# Town of Hilton Head Island Regular Design Review Board Meeting

December 11, 2018

***Town of Hilton Head Island***  
***Minutes of the Design Review Board Meeting***  
**November 13, 2018 at 12:00 p.m. Noon**  
**Benjamin M. Racusin Council Chambers**

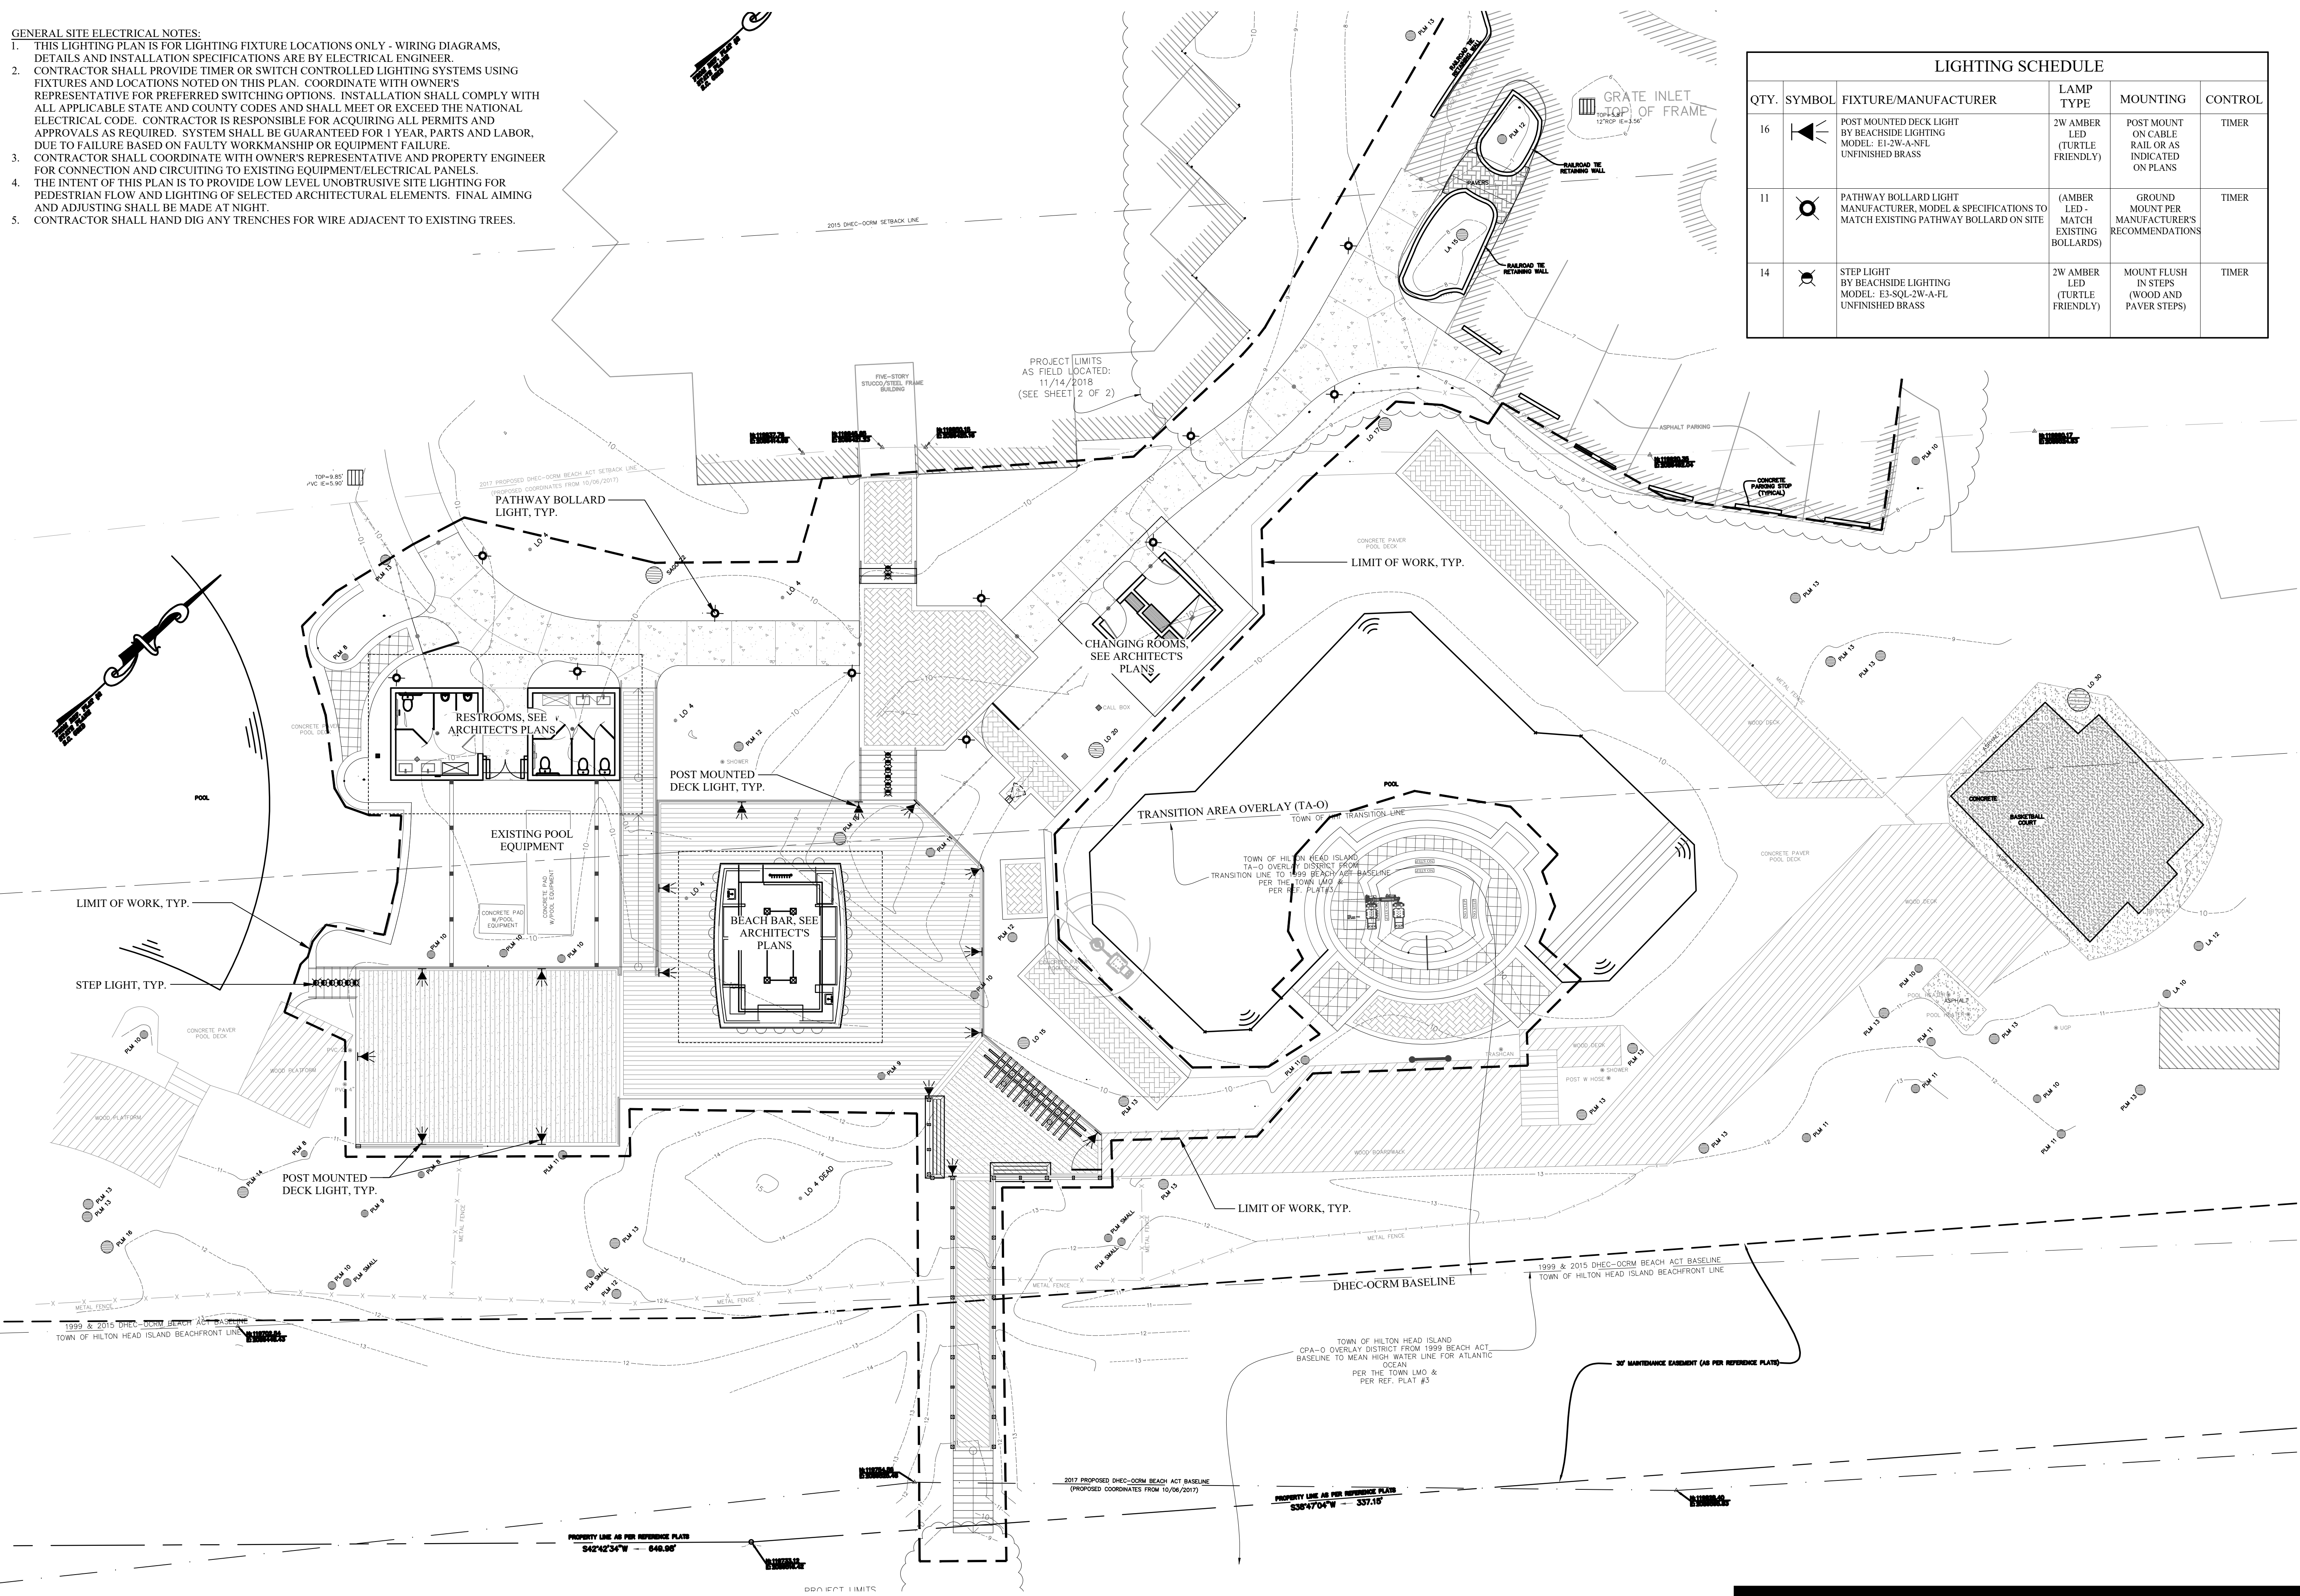
1. Upsize to 4" caliper size the proposed Live Oak to replace the mitigation oak that died.
2. Retain the 4" mitigation oak between the proposed bar and restrooms in its current location.

1. Maintain an accessible route throughout the site and building as per applicable codes.
2. This project requires a Minor Development Plan Review (DPR) application. Any proposed structures in the TA-O district cannot be enclosed and the bathroom square footage must be below 300 sq.ft. and properly flood vented.
3. Upsize (to 4") the proposed Live Oak to replace the mitigation oak that died (dunes in front of the proposed bar, noted as dead, sheet L-700).
4. Retain the mitigation oak in its current location labeled "RELOCATE EXISTING", sheet L-700.

PROPOSED  
 FLOOR PLAN

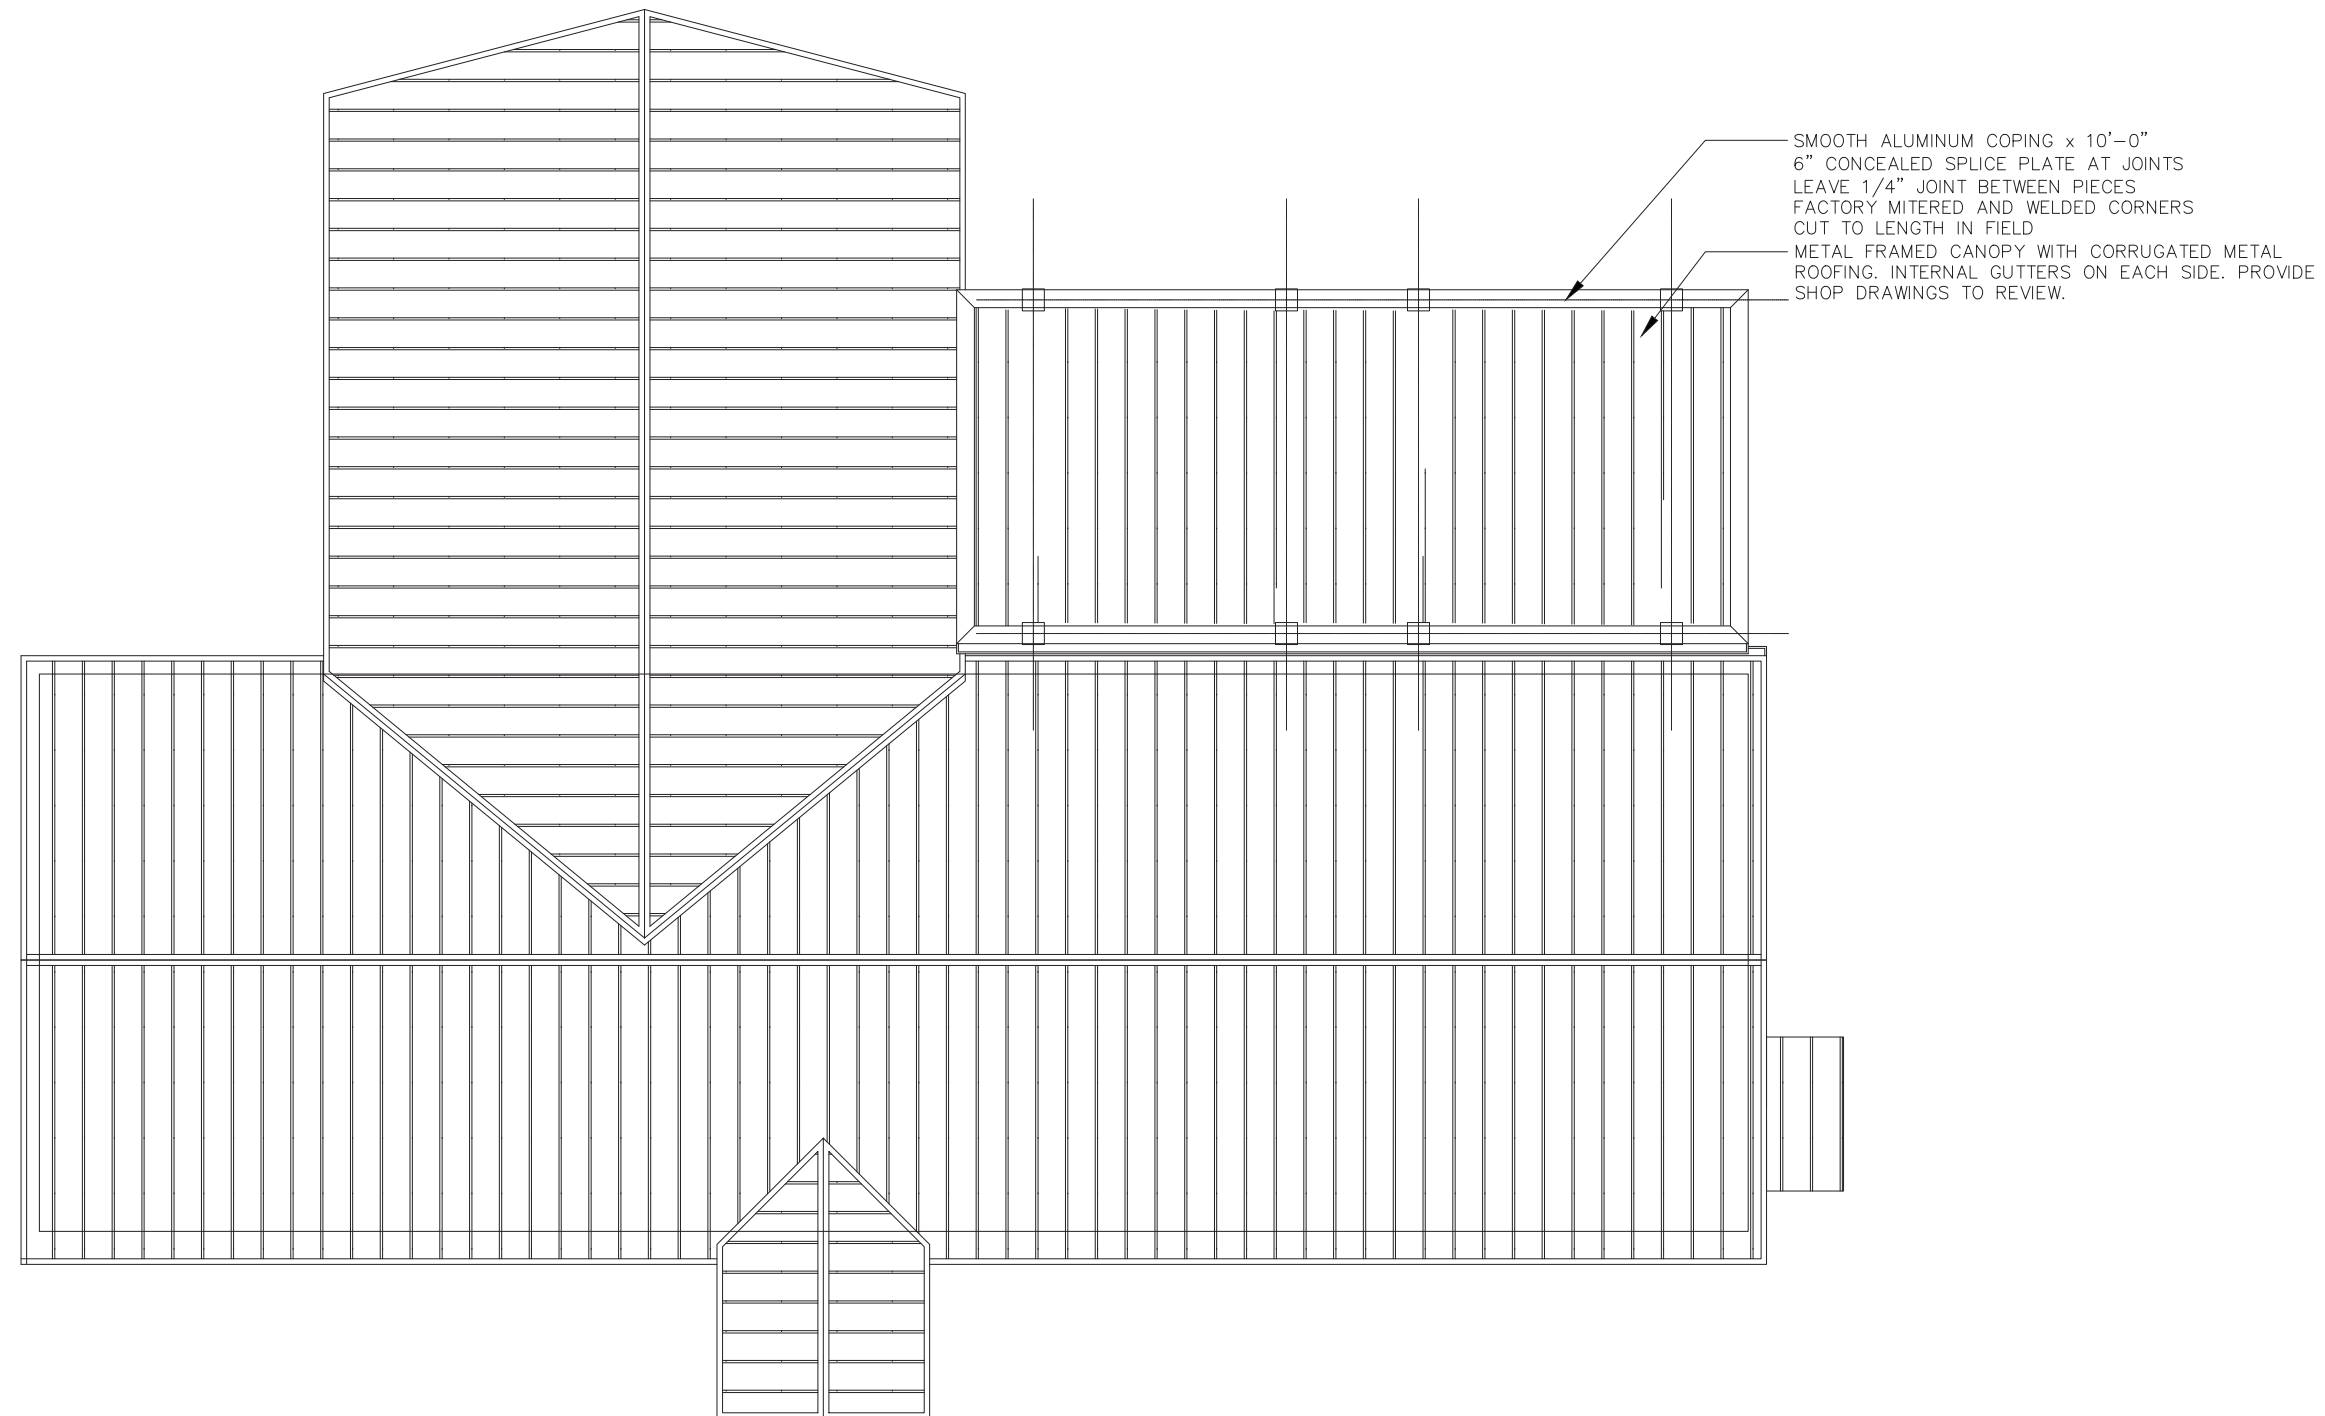
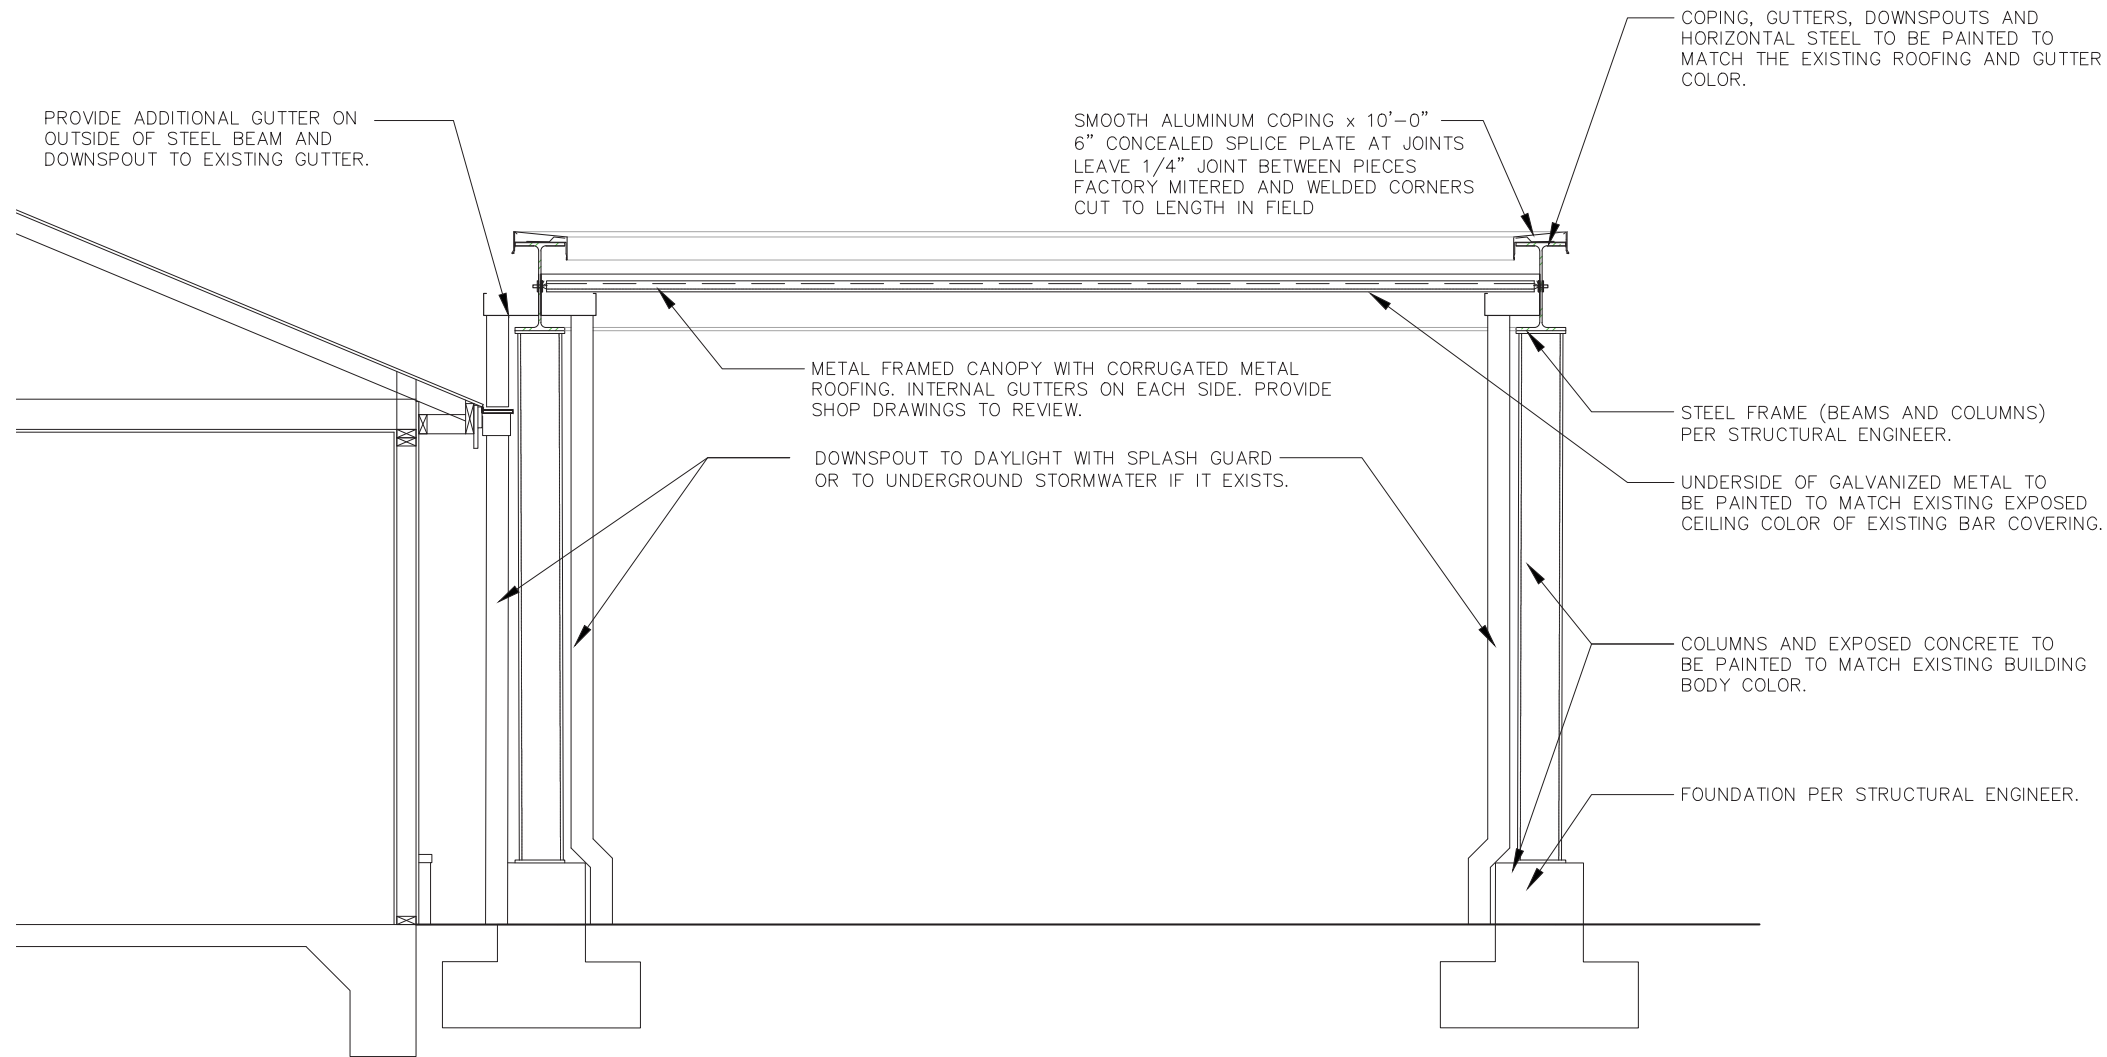
<b><i>APPLICATION MATERIAL</i></b>				
<b>DRB REQUIREMENTS</b>	<b>Complies Yes</b>	<b>No</b>	<b>Not Applicable</b>	<b>Comments or Conditions</b>
Dimensioned Details and of Sections	<input type="checkbox"/>	<input checked="" type="checkbox"/>	<input type="checkbox"/>	Details and sections are too conceptual. It is not clear that the proposed columns are wood.
Detail Illustrating Connection to Existing Structure	<input type="checkbox"/>	<input checked="" type="checkbox"/>	<input type="checkbox"/>	Too conceptual, for example how does the column relate to the existing deck?
New Building Details Match Existing Building Details	<input type="checkbox"/>	<input checked="" type="checkbox"/>	<input type="checkbox"/>	The roof has no relation to the tress system over the bar area.

<b><i>ARCHITECTURAL DESIGN</i></b>				
<b>DESIGN GUIDE/LMO CRITERIA</b>	<b>Complies Yes</b>	<b>No</b>	<b>Not Applicable</b>	<b>Comments or Conditions</b>
Structure is designed to be appropriate to the neighborhood	<input type="checkbox"/>	<input checked="" type="checkbox"/>	<input type="checkbox"/>	Architecture and building system should relate to the existing structure.
Has a strong roof form with enough variety to provide visual interest	<input type="checkbox"/>	<input checked="" type="checkbox"/>	<input type="checkbox"/>	The roof form does not relate to the existing structure.
Minimum roof pitch of 6/12	<input type="checkbox"/>	<input checked="" type="checkbox"/>	<input type="checkbox"/>	While a roof pitch of 6/12 is not required, given the size of the addition, matching the existing pitch or providing any discernable pitch is preferable.

<b><i>MISC COMMENTS/QUESTIONS</i></b>				
1.	Will the existing deck be extended under roof?			
2.	Please locate the existing rope and bollard railing at the edge of the existing deck on the plans.			
3.	To obtain a building permit, the structure shall be anchored to resist wind loads per IBC 2015 and ASCE 7-10. Design required to be stamped by a SC registered architect or engineer. Will this affect the aesthetics of the structure?			
4.	Any pruning of existing trees must be done to ISA standards and approved under a HHI Natural Resource Request.			
5.	This project requires a Minor DPR approval.
